THE CITY OF SAN DIEGO

MEMORANDUM

SUBJECT: Mission Beach PDO – Response to Recommendations of June 17, 2010

# Planning Commission Recommendations for Mission Beach PDO

**DIAGRAM 1** (illustrating strict Dormer only zoning envelope)

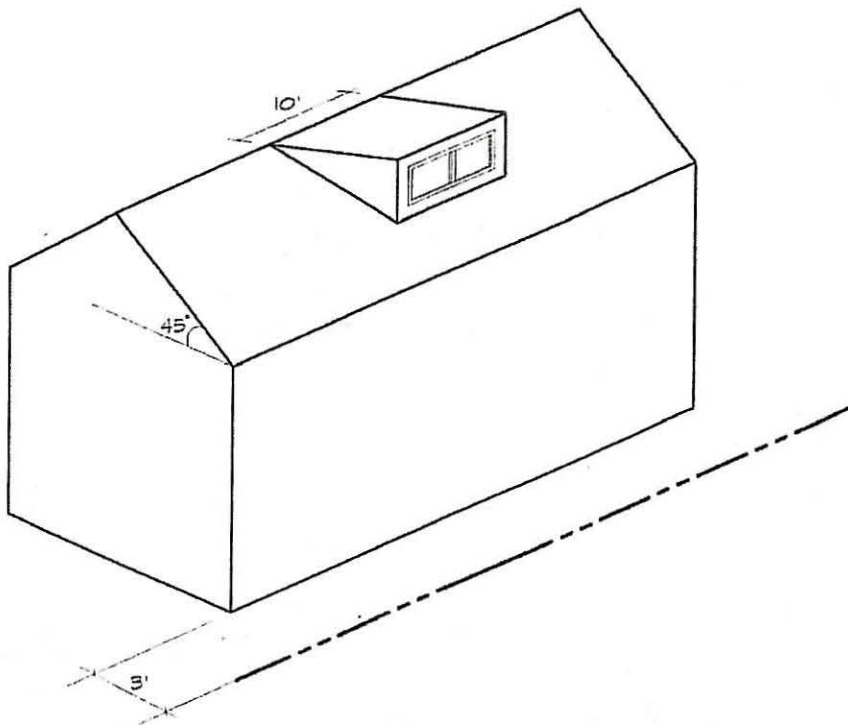
**CONCERNS:** The definition of this element limits the allowable encroachment defined elsewhere in this PDO to ONLY the condition described on the new definition. (see Diagram 1 below showing the exclusive Dormer use)

- (C) Roof decks shall be permitted to encroach into the 45 degree angled setback consistent with the setback, locational, and dimensional requirements for dormers in Section 1513.0304(d)(4)(B).

**DIAGRAM 2** (showing a roof deck as a sample of a non-Dormer use in the Dormer allowed zoning envelope)

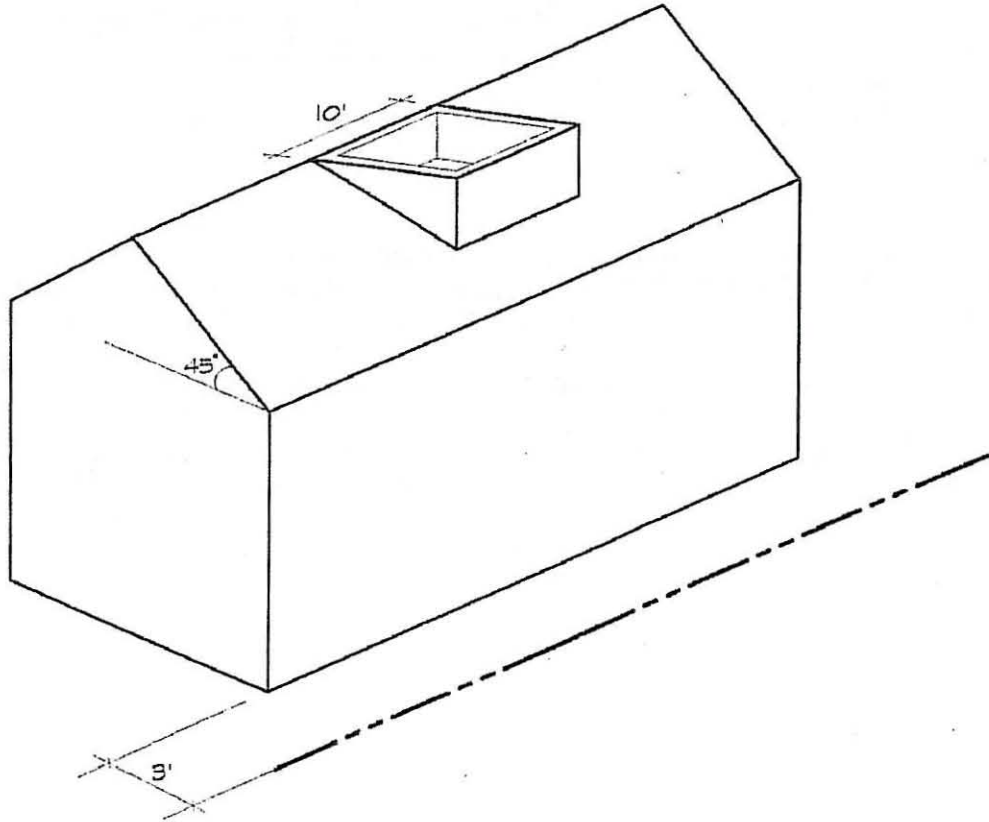
**SUGGESTED MODIFICATION:** Either the definition or the location of the allowable encroachment should be modified to encourage and allow similar uses in the zoning envelope encroachment allowed by this section. For example, a designer might want to allow a 10' wide roof deck in the zoning envelope allowed for the fully enclosed dormer footage but with this new section it would not be allowed even though the roof deck example presents significantly less mass or volume, due to the extremely restrictive definitions, it would not be allowed yet if you put a roof over the same deck and enclosed the walls on all sides, it would be allowed and that simply makes no sense. Latitude should be included to allow any structure, element or projection to fully utilize the allowable envelope prescribed in the zoning limitations. (see Diagram 2 example below of a roof deck and how it fits within the same zoning Envelope)

**DIAGRAM 1** (per PDO offset code section)

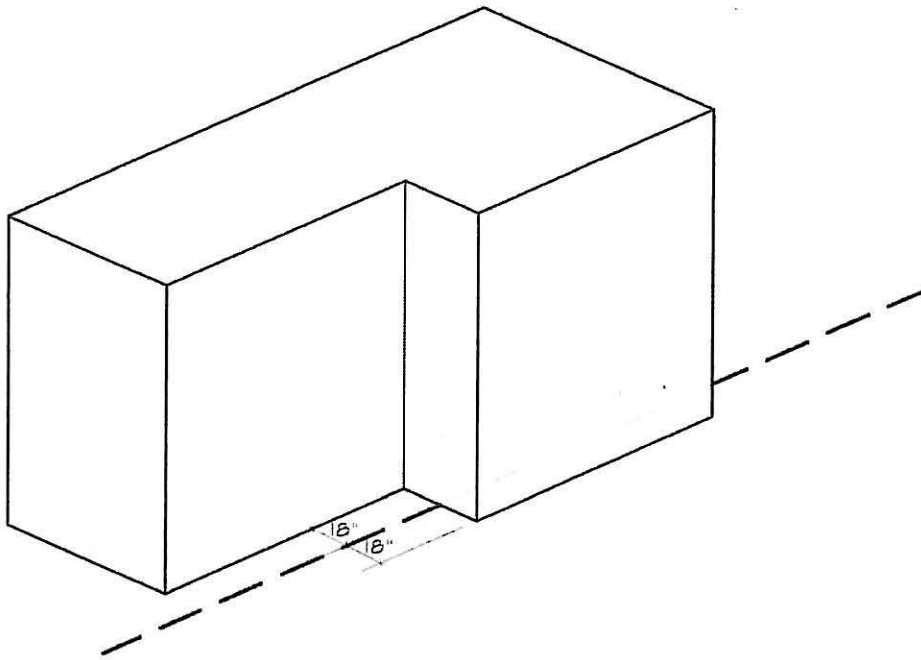
**CONCERNS:** This section must be clarified in much greater detail and has been interpreted countless ways by City Staff over the years.

**SUGGESTED MODIFICATION:** The issue that must be clarified is what exactly is allowed within the "inset" setback and what is allowed on the "outset" setback. Over the years, City Staff have allowed the building mass or ENCLOSED envelope ONLY to be required to observe the prescribed inward and outward setback to promote façade articulation and this would allow decks or other significant Architectural features to encroach into the inward setback provided there is no enclosed mass or volume. As an example, see the Diagram 1 below which illustrates the intent of the PDO and Diagram 2 which illustrates the staff interpretation where balconies and roof overhangs are added to the inward setback footprint completely destroying the intent. Clarification must be provided as to what can be placed in the 3' inward offset.

9	1513.0304(d)(2)(A)(i)	17	<b>Done.</b> Modified language to clarify that only those encroachments in Table 1513-03B are permitted in the offset and the inset.

- The width of the offset that encroaches is not more than one-half of the total building width extending the full height of the building, and
- An inset area equal to the width of the encroaching offset at a minimum depth of 18" is undeveloped behind the required setback line parallel to the Court, Place, or Walk.
- Only those encroachments identified in Table 1513-03B are allowed in the offset and inset areas.

**Diagram 1513-03C**  
Interior Yards and Building Height

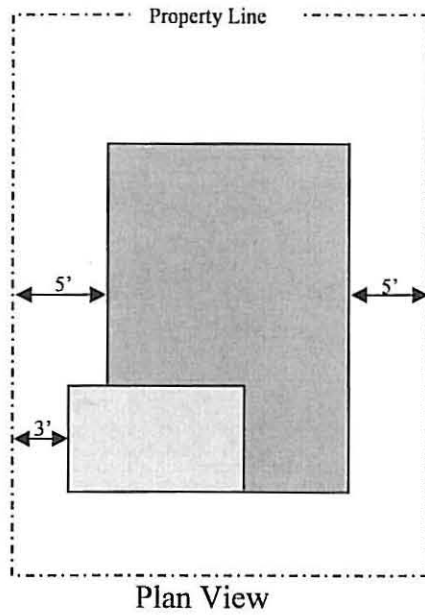
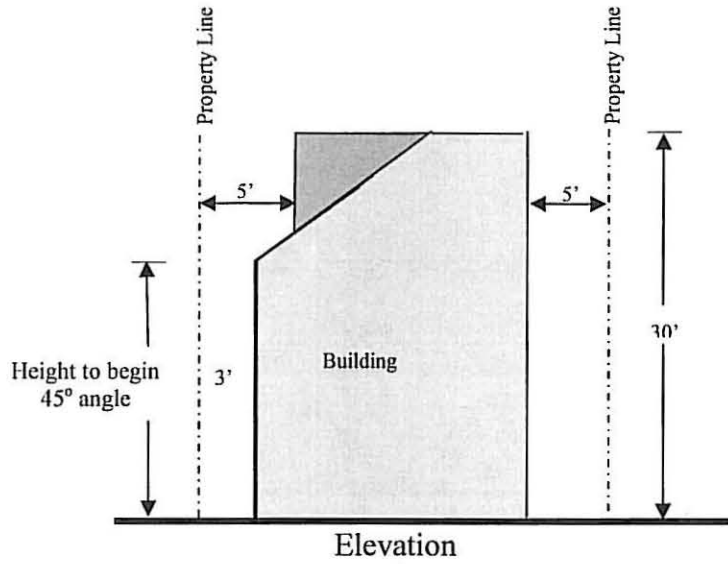
**CONCERNS:** Diagram that accompanies this section is problematic.

**SUGGESTED MODIFICATION:** The sample diagram illustrates the 3'-0" side yard setback section of the building terminating below the implied maximum height limit. I suggest the drawing be modified to show both setback options terminating at the same height so as not to imply one setback option can not go to the maximum height limit.
